Hillside Park

Definitive Subdivision)

General Overview of Changes to plans since last Planning Board Meeting

MODIFIED DEFINITIVE PLAN
HILLSIDE PARK
MELROSE, MA
1/27/2020 NTS

SHEET 2

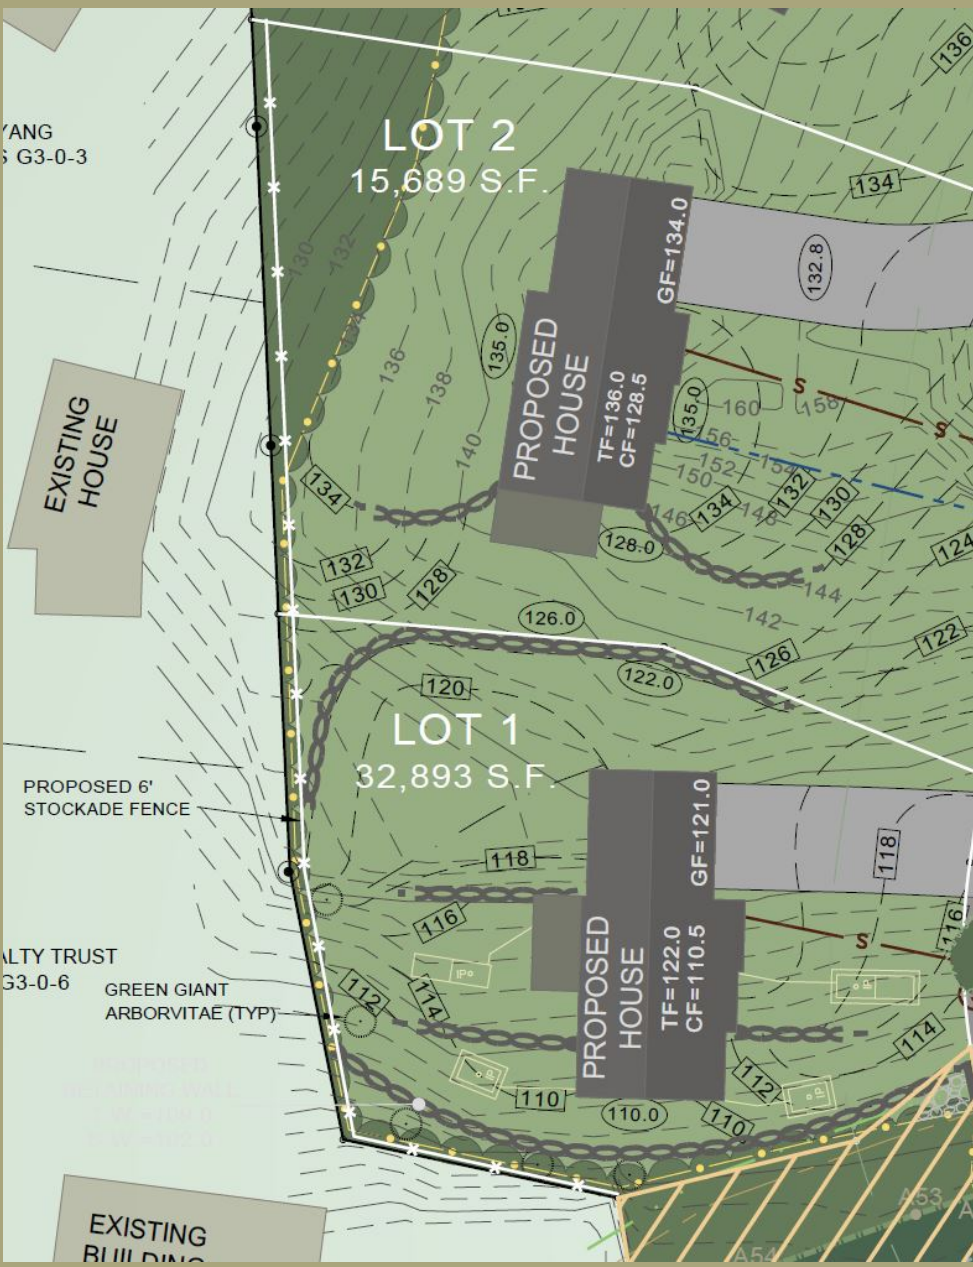
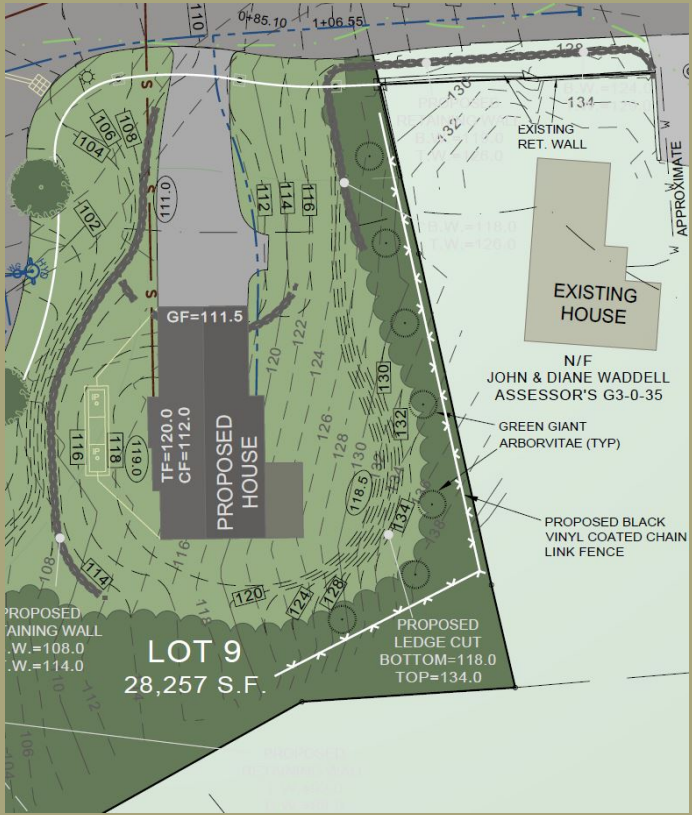
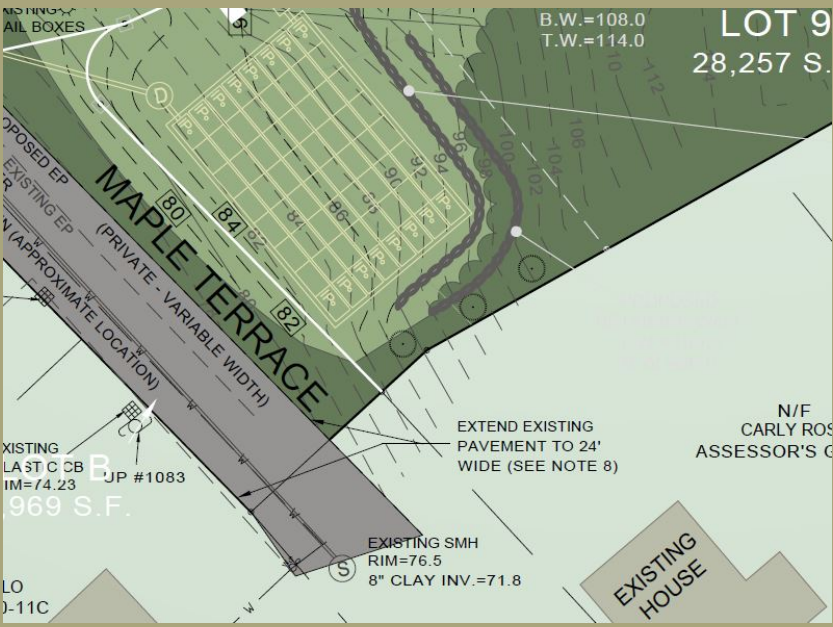
Maple Terrace Provisions

- ❖ New Water Line
- ❖ Widened Pavement
- ❖ New Sidewalk
- ❖ New Drain Culvert
- ❖ Repairs to sewer services

❖ Fencing and Vegetative screening Added in select locations
